STANDARD FIELD SERVICE BULLETIN

FSB Number	CHRAEFSB2014-111
Author	Rajesh Verma
Date	11/03/2014
Subject	Moto X (2nd Generation) - Wood / Leather Inlay Lifted
Model Affected	XT1092, XT1093, XT1094, XT1095, XT1096, XT1097
Level Of Repairs	Level 2

Figure: 5

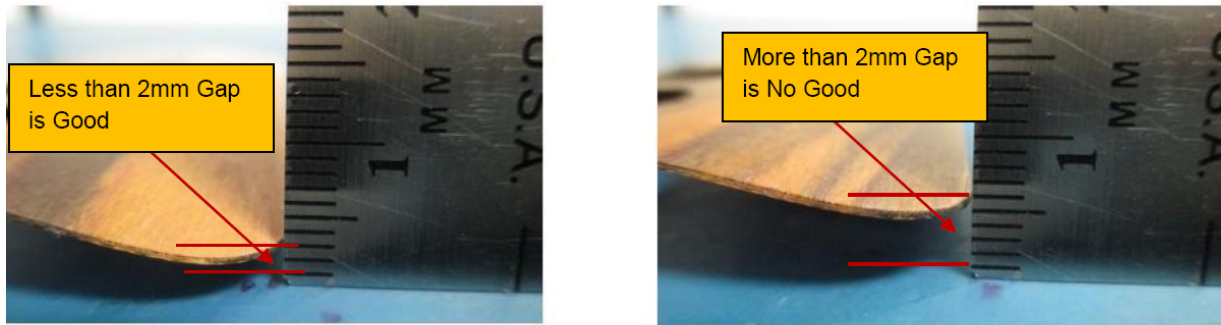
1. Inspect Wood/Leather inlay for any lift at the corners and on the sides, if confirmed then,
2. Measure the Wood/leather inlay lift per spec specified in the service manual. If lift is excessive/out of spec then;
3. Per Service Manual, disassemble the inlay.
4. Inspect new Wood inlay part for flatness as shown in Figure 5 below.
5. Replace the inlay with a good known new part.

Figure: 4

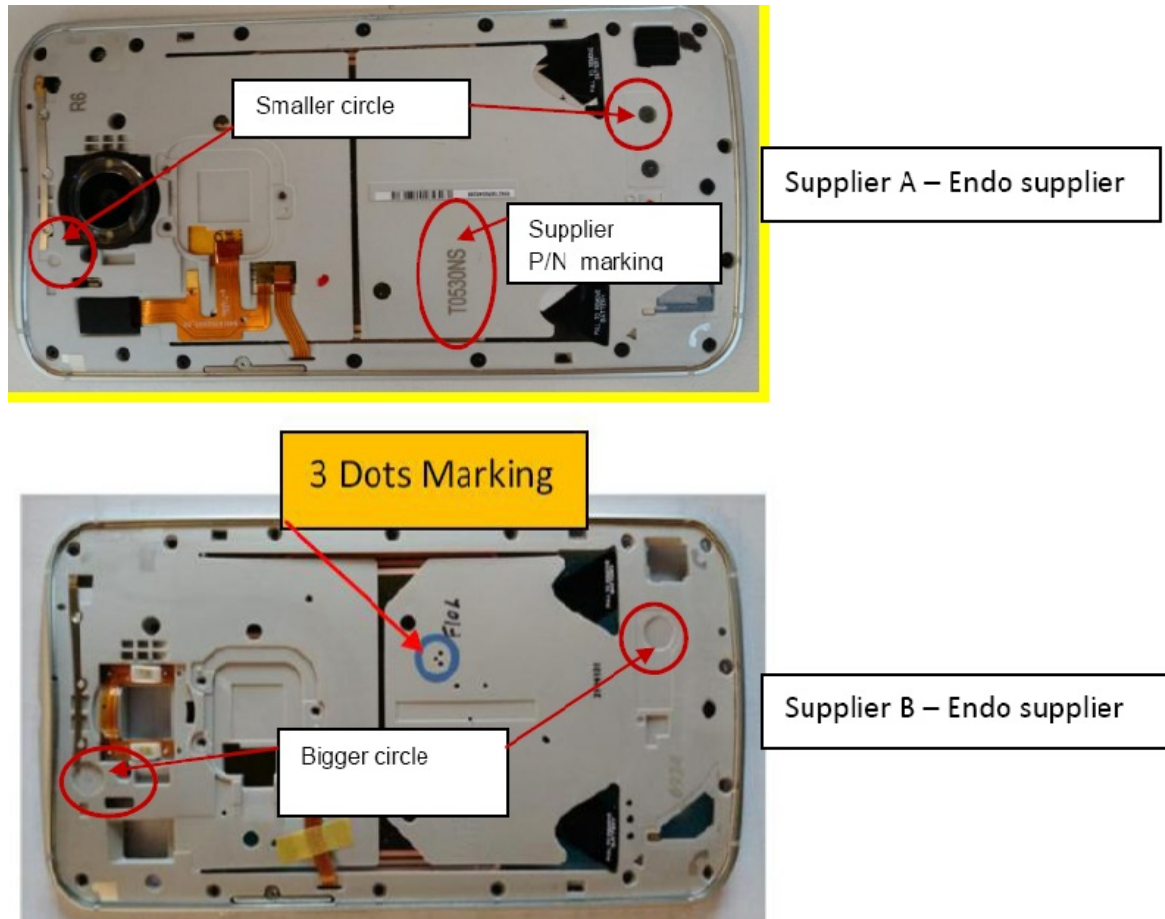
- a) Supplier A, good parts have “smaller circle” and part number marked (see Figure 4).
- b) Supplier B, good parts have “bigger circle” and “3 dots” marked.

- Stock Endo p/n # 010179390XX & 0101182620XX (ASSEMBLY,SUB,INNER REAR HOUSING).
 - **Note 4:** Screen existing inventory of Endos p/n # 010179390XX & 0101182620XX as shown below in Figure 4.
 - Supplier A, parts have “smaller circles” and “p/n marked” (see below Figure 4) - All parts are good from this supplier and no screening is require.
 - Supplier B, parts have “bigger circles” and “3 Dots marked” (see below Figure 4). If no “3 Dots marked then parts are not good to use.
- Stock Wood Inlay p/n 0101796900X
 - **Note 5:** Existing inventory of Wood Inlay p/n 0101796900X should be screened for warp and out of spec flatness. See Figure 3 above.
